Technical Service Bulletin

Cobra Motorcycle Mfg.

TSB0605: Fuel Petcock for all Cobra

June 29, 2005

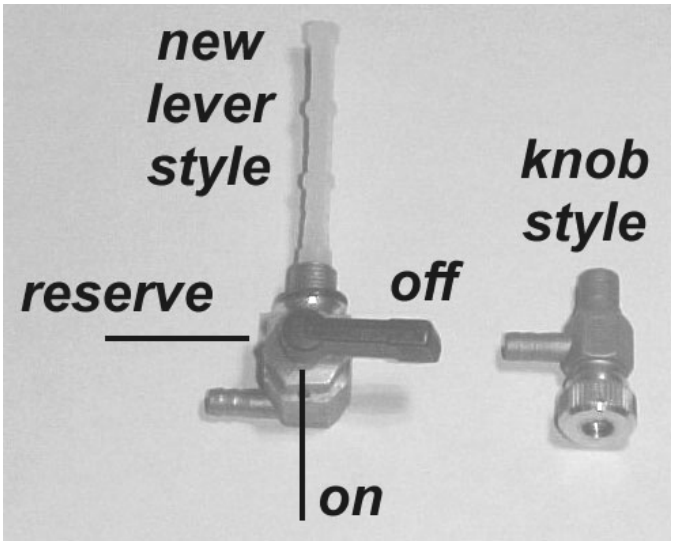
The knob style fuel petcock (figure below) is being discontinued by Cobra. It will be replaced on all future units by the lever style shown below (TCMU0000). This lever style, as well as the older lever style, has been approved by the AMA for use in all 2005 MY (Model Year) and older products.

You may notice that the new petcock is similar to the lever style used in 2004 and earlier, however, the new unit may be installed such that the lever cannot easily be bumped in the “on” and “reserve” positions, while the fuel line is routed directly under the tank.
